SUNDRY NOTICES AND REPORTS ON WELLS
Do not use this form for proposals to drill or to re-enter an abandoned well. Use form 3160-3 (APD) for such proposals.

5. Lease Serial No. NMLC071985
6. If Indian, Allottee or Tribe Name
7. If Unit or CA/Agreement, Name and/or No.
8. Well Name and No. WAR HAMMER 25 FEDERAL COM 5H
9. API Well No. 30-025-43391
10. Field and Pool or Exploratory Area WC-025 G-09 S263225A; WOL
11. County or Parish, State LEA COUNTY, NM

ConocoPhillips request to have the access road out of the SW corner of the dual pad and have the temporary road out of the NW corner of the well pad. The temporary road will be reclaimed after drilling. The access road will be constructed with caliche, and be 14 feet long, with a 30 foot wide ROW for 20 feet of drivable surface and 5 feet on each side in order to accommodate the size of the rig.

ACCESS ROAD R-O-W

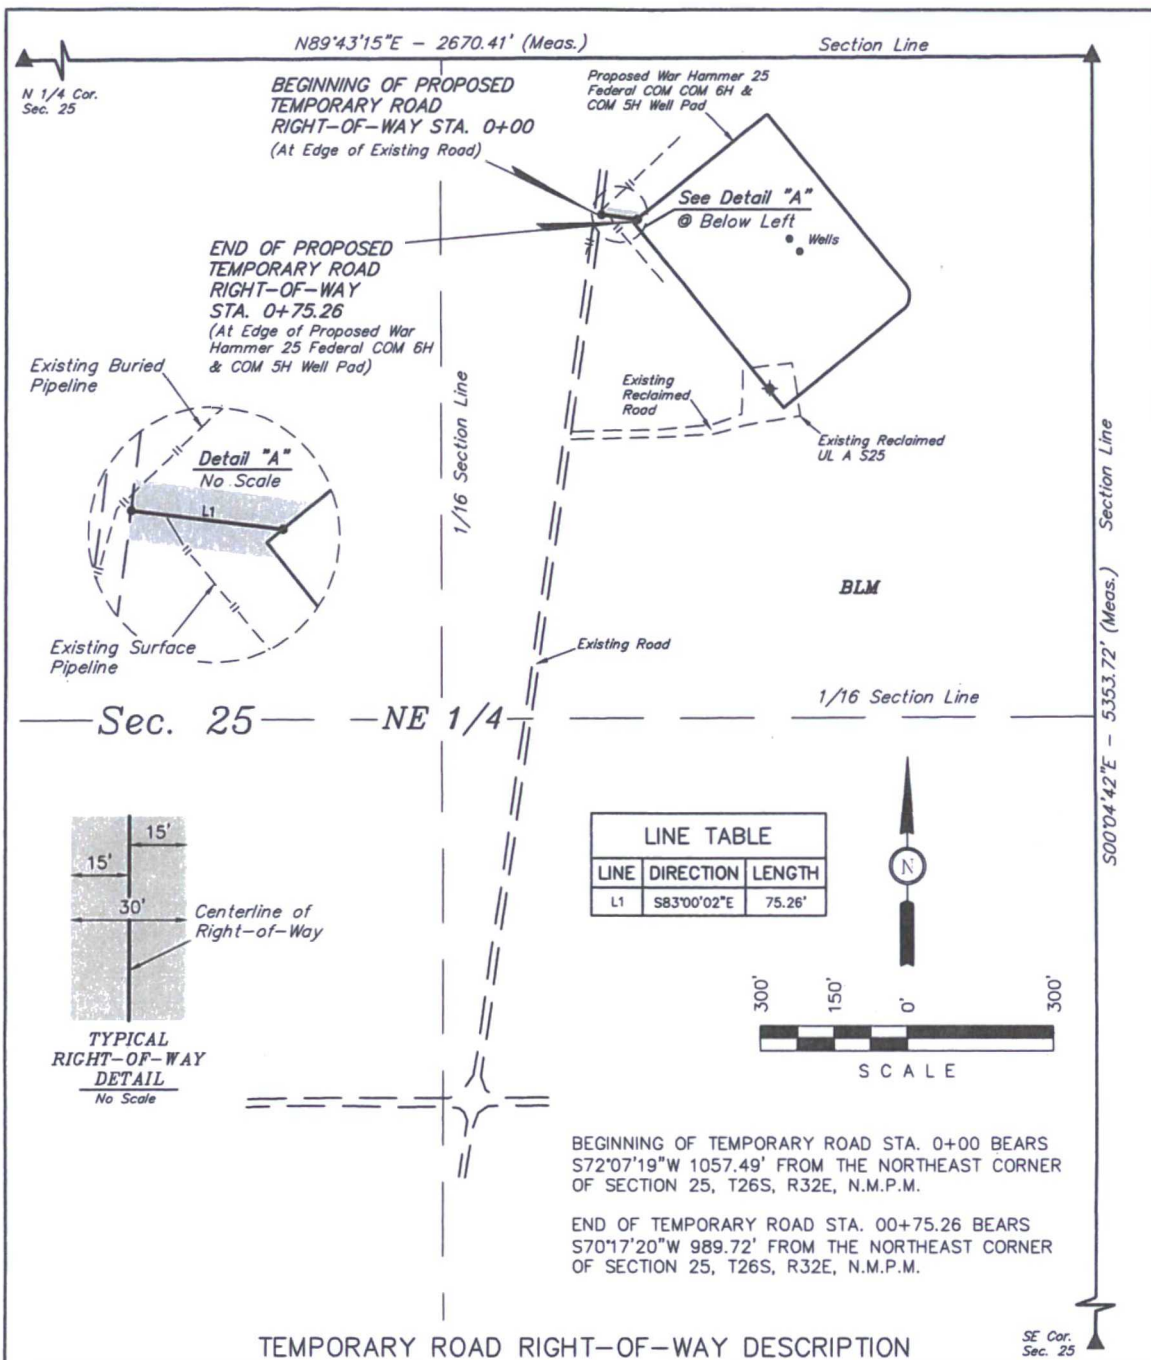
A 30' WIDE RIGHT-OF-WAY 15' ON EACH SIDE OF THE FOLLOWING DESCRIBED CENTERLINE.

BEGINNING AT A POINT IN THE NE 1/4 NE 1/4 OF SECTION 25, T26S, R32E, N.M.P.M., WHICH BEARS S41°01'27"W 964.93' FROM THE NORTHEAST CORNER OF SAID SECTION 25, THENCE NORTH 14.27' TO A POINT IN THE NE 1/4 NE 1/4 OF SAID SECTION 25, WHICH BEARS S41°35'12"W 954.21' FROM THE NORTHEAST CORNER OF SAID SECTION 25. THE SIDE LINES OF SAID DESCRIBED RIGHT-OF-WAY BEING SHORTENED OR ELONGATED TO MEET THE GRANTOR'S PROPERTY LINES. BASIS OF BEARINGS IS A G.P.S. OBSERVATION. CONTAINS 0.010 ACRES MORE OR LESS.
